**RE: 2016-2017-2018 Inspections Report, Limited Mining Operation (LMO) 1496ET, Quality Landscape & Nursery, Inc.**

**LIMITED MINE OPERATION (LMO)  
INSPECTION REPORT**

<b>LMO Number:</b>	ET1496	<b>Operator:</b>	QUALITY LANDSCAPE & NURSERY INC
<b>Inspection Date:</b>	3/27/2018	<b>Inspector(s):</b>	Rich Vincent
<b>Report Date:</b>	6/4/2018	<b>Participant(s):</b>	Randy Stevens, Quality Landscape & Nursery, 2016, 7/2017 & 2018; Brian Goodnough, LQD District 1, 6/2017; Dan Ferrin, Saratoga Zoning and Planning Director, 3/2018; Steven Wilcoxson, Citizen-Complaint Filer, 3/2018
<b>Last Inspection:</b>	6/4/2015	<b>Current Bond:</b>	\$1,000
<b>Inspection Reason(s):</b>	Annual, Complaint	<b>Field Conditions:</b>	
<b>Status:</b>	Active	<b>Approved Acreage:</b>	1
<b>County:</b>	Carbon	<b>Mineral:</b>	Dirt
<b>Total Disturbed Acres:</b>	1

Photo 5 Overview of operation & west side from the NW corner, note sediment containment & operation delineation needed on west side (2018).

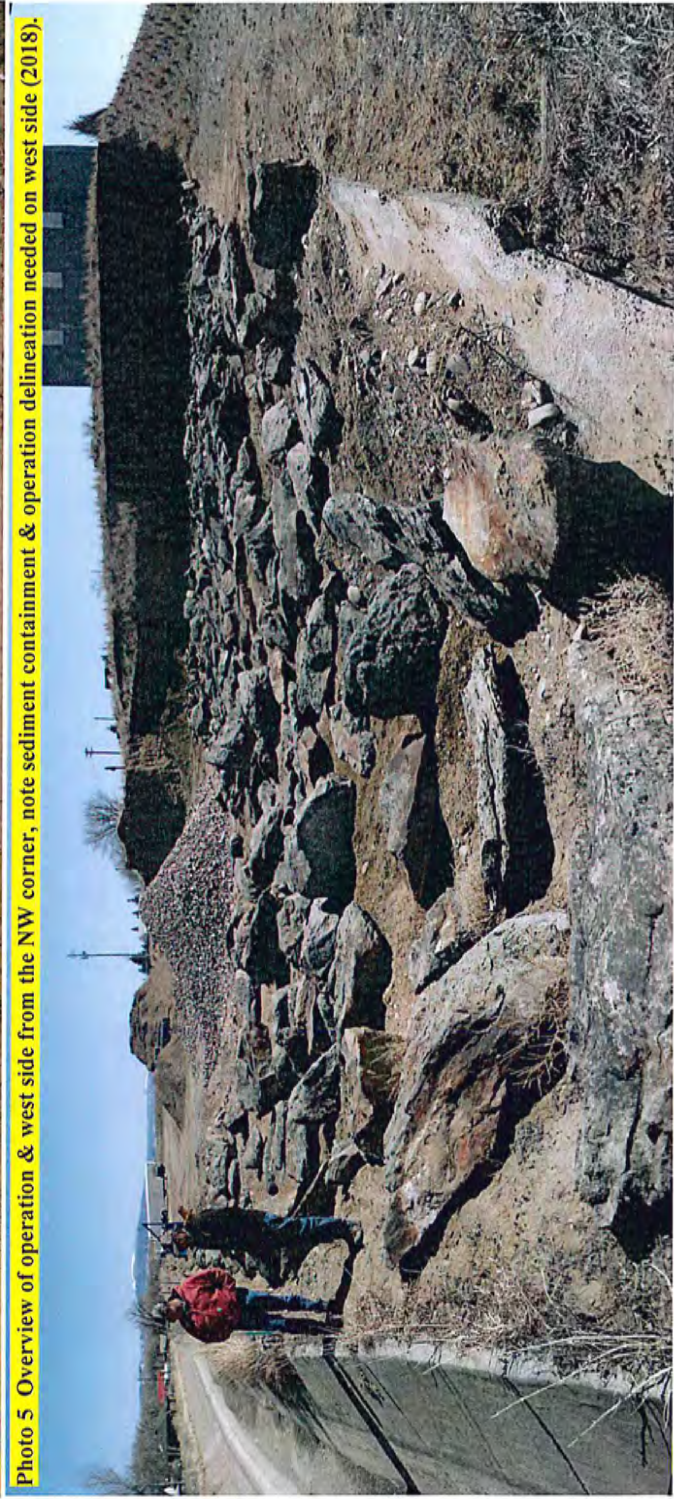
The remaining LQD concern relates to the delineation and sediment control along the west side of the operation between your property and the Wyoming Department of Transportation property. Please install a ditch or berm along the western edge to delineate your boundary, keep disturbance within your LMO boundary, and contain potential sediment on site. Please complete this work and submit photo documentation to the LQD by **June 15, 2018**.

Inspection Topic	Inspection Date	Proposed Resolution Date
Erosion Control	3/27/2018	6/15/2018
Install a berm along a portion of the west side of the operation, to delineate the LMO boundary and contain sediment onsite, and provide photo documentation to the LQD by June 15, 2018.

Photo 7 North side steel wall, note all material mined from in front of the wall (2018).

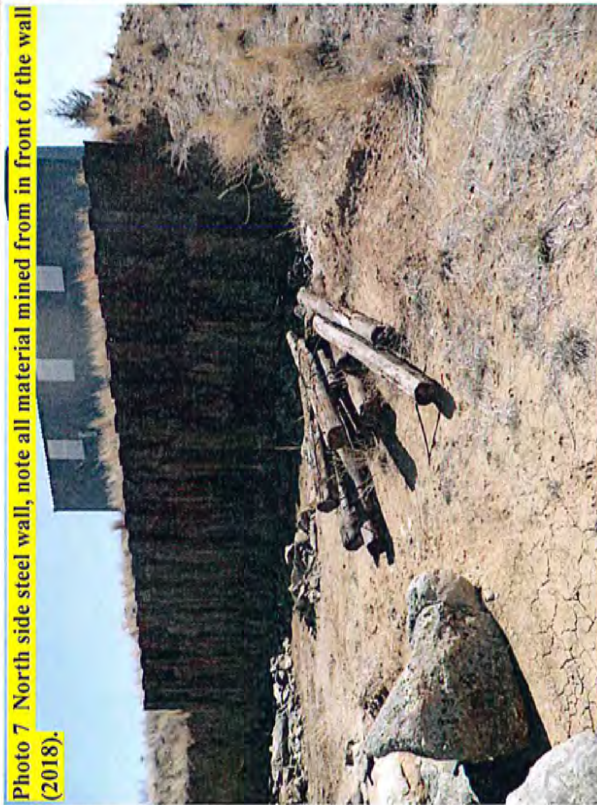
Please note that mining disturbance of LMO 1496ET encroaches approximately 2 feet south of the property boundary. During the inspection, it was acknowledged by Mr. Wilcoxson (Saratoga Town Council member) that the Town of Saratoga instructed you to mine up to the steel retaining wall. As noted during the March 2018 inspection by all parties, in the Planning and Zoning Dept.'s 3/27/18 Daily Report, and the Wyoming State Mine Inspector's report summarizing his April 3, 4, and 19, 2018 inspections, the safety of the steel retaining wall is a concern. Also as noted during the 3/27/18 inspection, neither the Town of Saratoga nor you are willing to conduct repair or maintenance work directly related to the wall without approval and concessions from the other party. Therefore, as noted, the issues involving the steel wall maintenance and other issues concerning the final status along your south side property line with the Town of Saratoga will be resolved via legal means. The earthen highwall sloping and grading, as well as the berming and fencing on the north side of the steel wall meet the minimum requirements of the LQD and the Wyoming State Mine Inspector's Office. Thank you for completing this work.
